# Chapter 3

## Responses to Comments

1  
2  
3 This chapter includes responses for each of the numbered comments identified in the comment  
4 letters in Chapter 2, *Comments Received on the Draft EIR*.

Figure 3-1. AM Peak Northbound Capacity, 2040 No Project and Project Scenarios

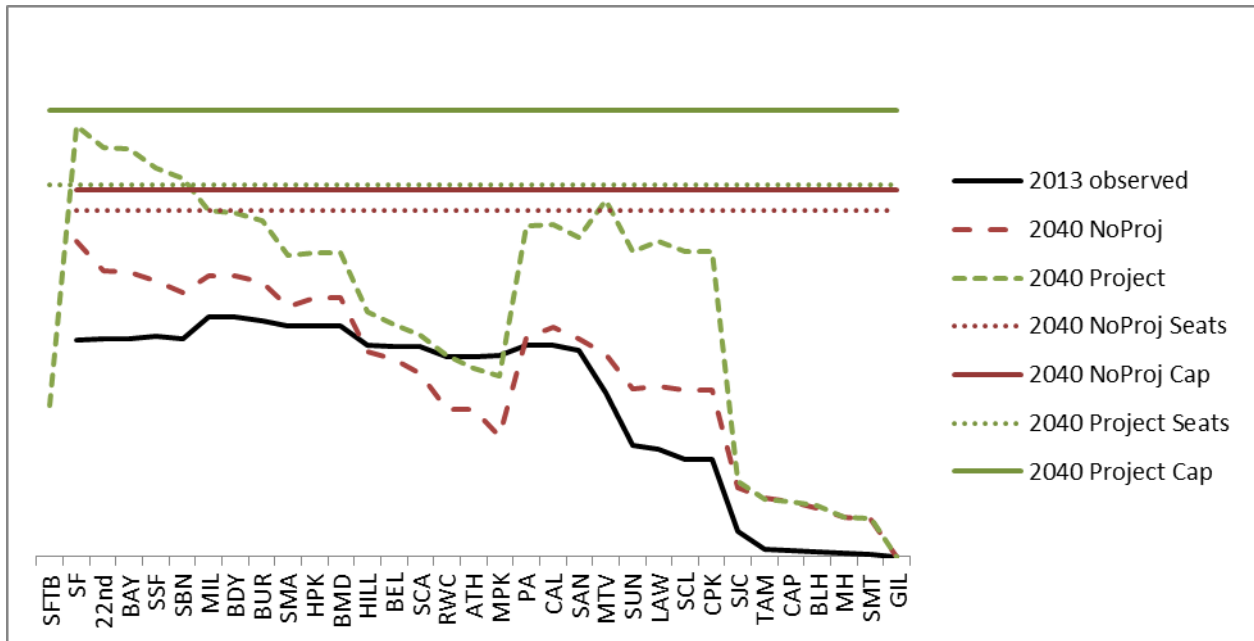
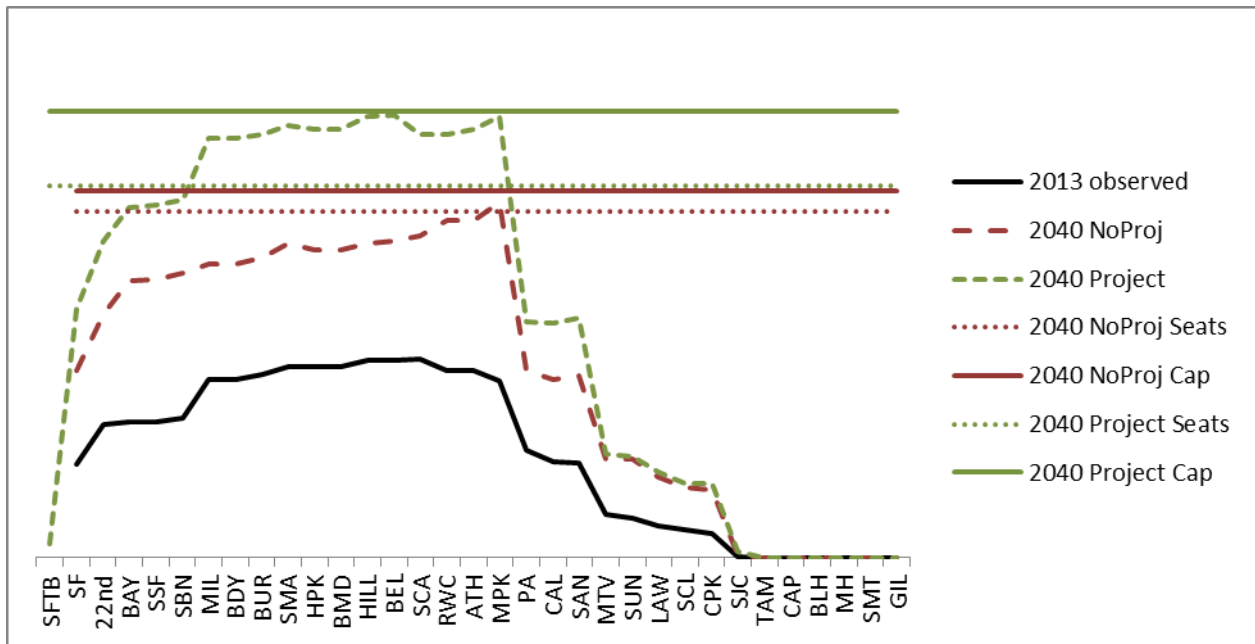
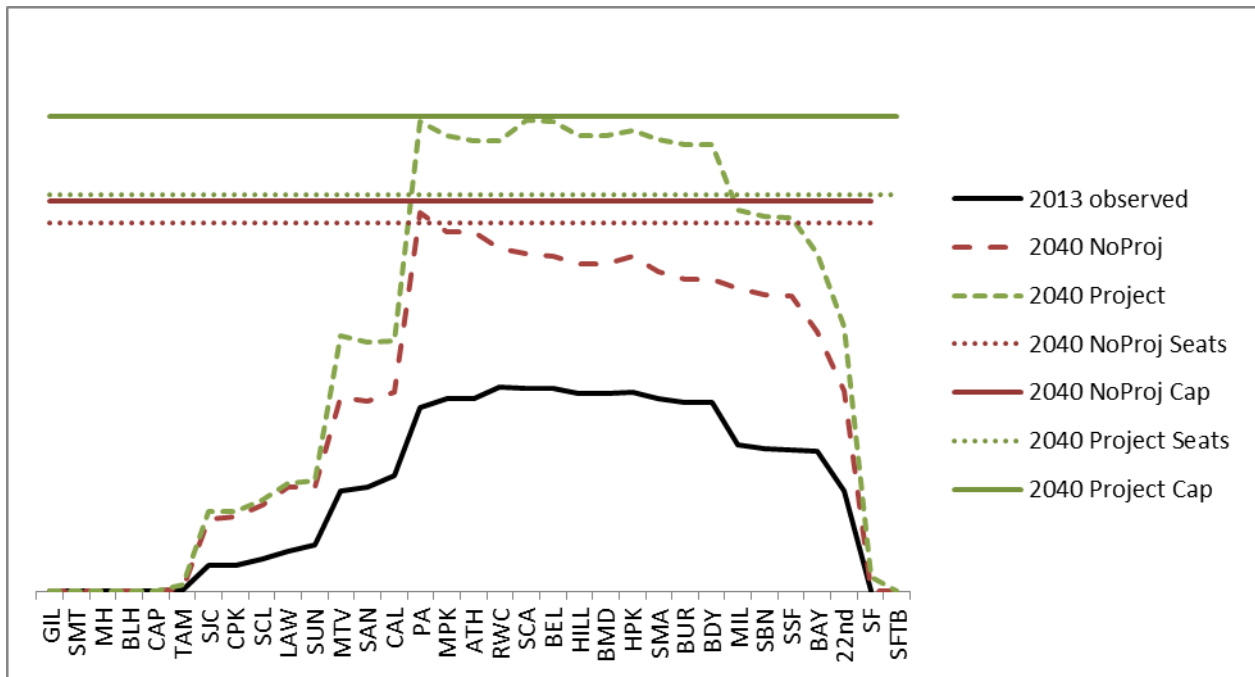
34 **Figures 3-1 to 3-4** below present an approximate visual summary of the capacity utilization and  
35 ridership projections presented above. They incorporate the projections from both 2040 scenarios,  
36 along with the adjustments described above to account for demand shifting away from the peak  
37 period. The change in passenger loading factors from the 2040 models to the factors used in the  
38 capacity analysis was accounted for indirectly by adjusting the scale of the model results. The dotted  
39 lines represent the seating capacity, with the solid lines incorporating standing room as described in  
40 the assumptions above. The capacity for 2013 is identical to the 2040 No Project scenario.

22 **Figure 3-5. Schematic diagram showing current flow in an autotransformer feeding system**  
 23

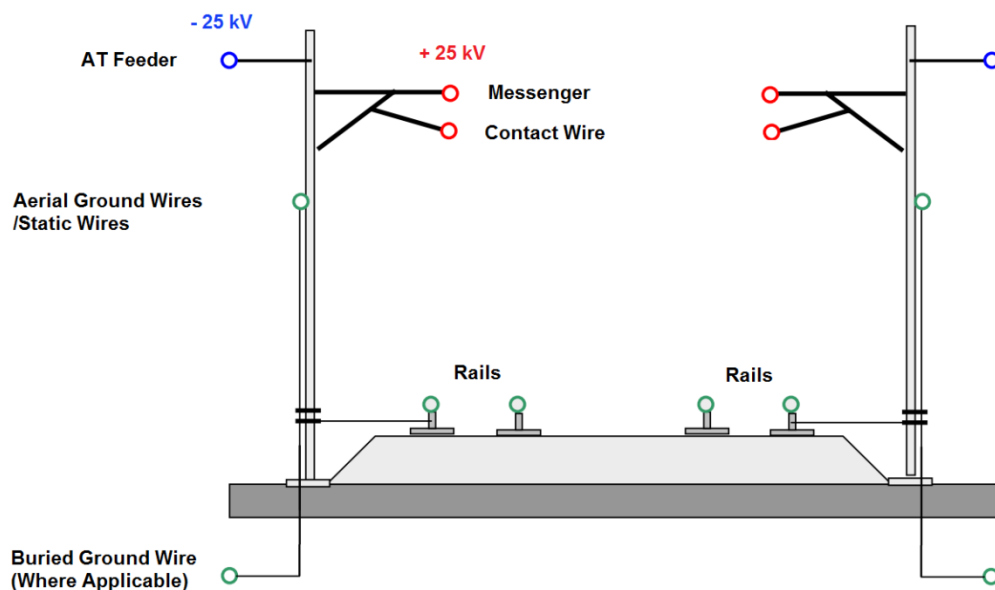
5 **O16-35**

6 The autotransformer feeding system that is proposed for Caltrain electrification is a single phase  
 7 feeding scheme. This is illustrated in Figure 3-5 and Figure 3-6 below.

14 When a train draws power from (or feed power back to) the OCS in Feeding Section 3, as shown in  
 15 Figure 3-5, the two adjacent ATF stations (ATF Station 2 and ATF Station 3) pick up the return  
 16 current from the running rails and transform it to current in the ATF Feeders. In Feeding Section 2  
 17 and Feeding Section 1, the OCS current is virtually equal to the ATF Feeder current, leaving virtually  
 18 no current flowing in the running rails. Due to the 180 degree phase displacement between OCS  
 19 voltage and ATF Feeder voltage, the OCS current and the ATF Feeder current are displaced by 180  
 20 degrees as well. As a result, the EMI effect in the surrounding environment is significantly reduced  
 21 where the lateral distance from the rail line is sufficiently long.
